Subject: AP1000 COL Response to Request for Additional Information (TR #61)

Responses to Request for Additional Information on Technical Report No. 61

RAI-TR61-001 through RAI-TR61-004

AP1000 TECHNICAL REPORT REVIEW

Figure 1 CRDM Cooling Air Flow Path in IHP

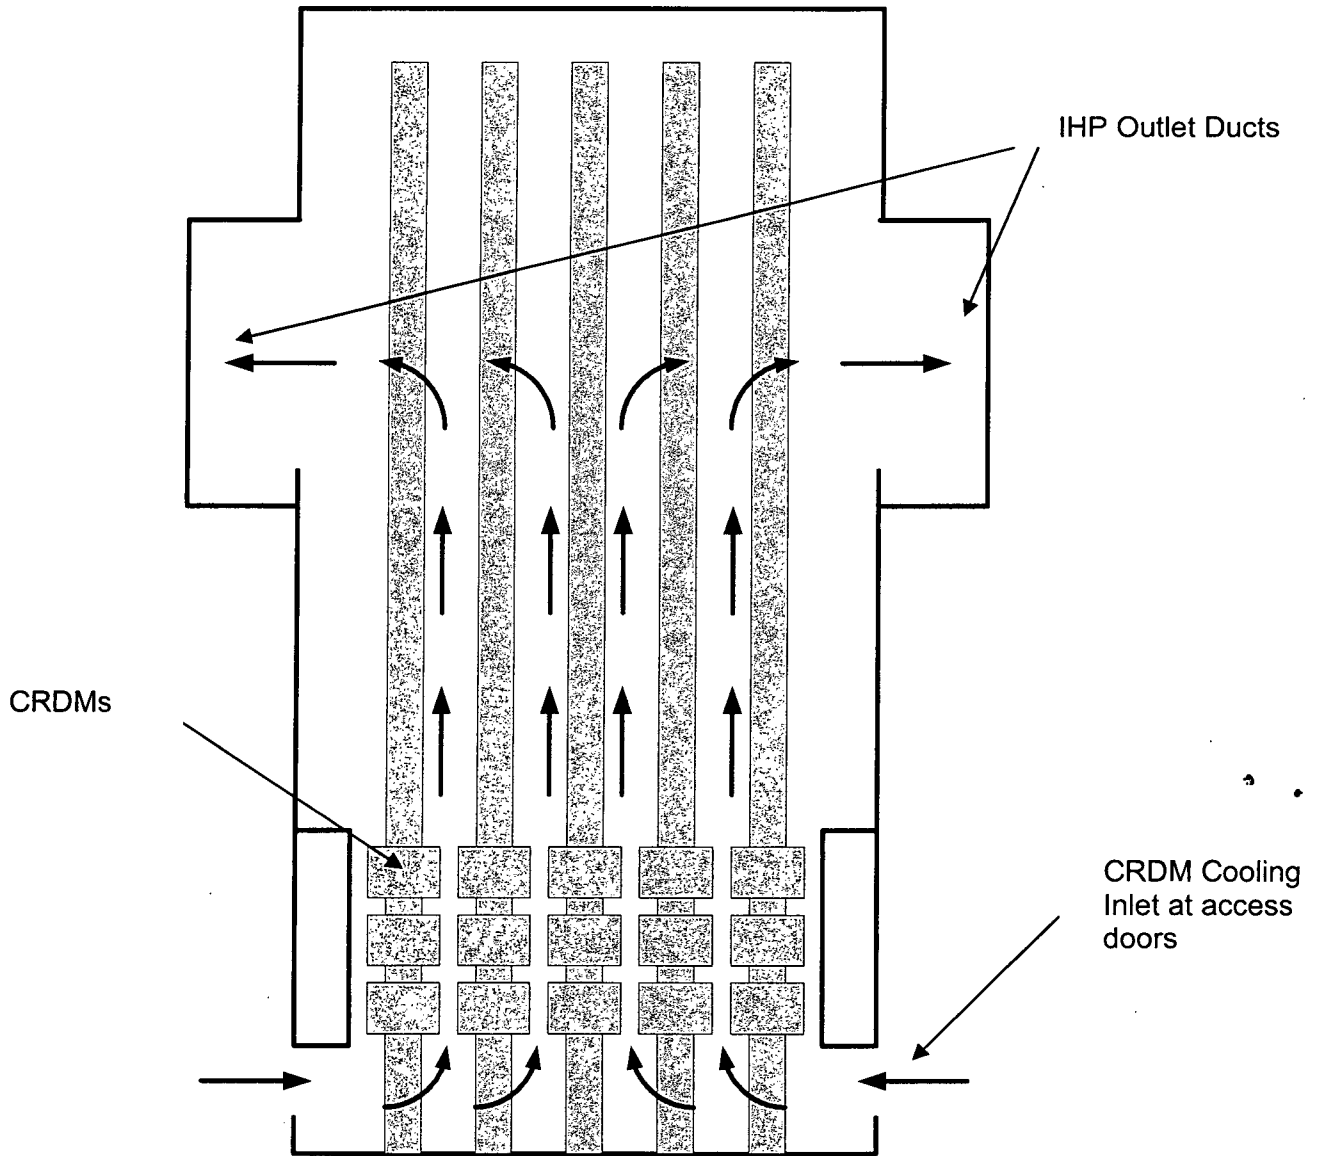
It is stated in AP1000 Licensing Design Change Document that the CRDM cooling fans would be relocated. Provide the dimensions and weights of the Integrated Head Package and the CRDM cooling fans. Also provide drawings (or schematics) to indicate the new proposed locations of the cooling fans and their support structure. The drawings should indicate the air flow path from the CRDM to the cooling fans and the increased distances of the fans in the revised location.

Figure 1 show the airflow path on the IHP itself. The air enters the IHP at the reactor vessel head elevation from the opened-during-operation access doors and is sucked upward parallel to the CRDMs before exiting two ducts 180 degrees apart on the IHP. The access doors are locked shut during refueling operations.

These two ducts on the IHP connect to short ducts on the CH-40 module via retractable elastomer duct connectors. The short ducts on the CH-40 module feed plenums below the cooling fans. Each CH-40 plenum feeds two cooling fans. The air is sucked upward through a cooling fan past a backdraft damper and through an outlet diffuser to the containment atmosphere.

The distance from the centerline of the duct on the IHP to the plenum on the CH-40 module is 65 inches. The total length of the plenums under the CRDM Cooling Fans are 88 inches. A CRDM cooling fan is 36 inches diameter (at the outlet diffuser) and 73 inches high (including the seismic isolator pad) and weighs approximately 2,500 pounds.
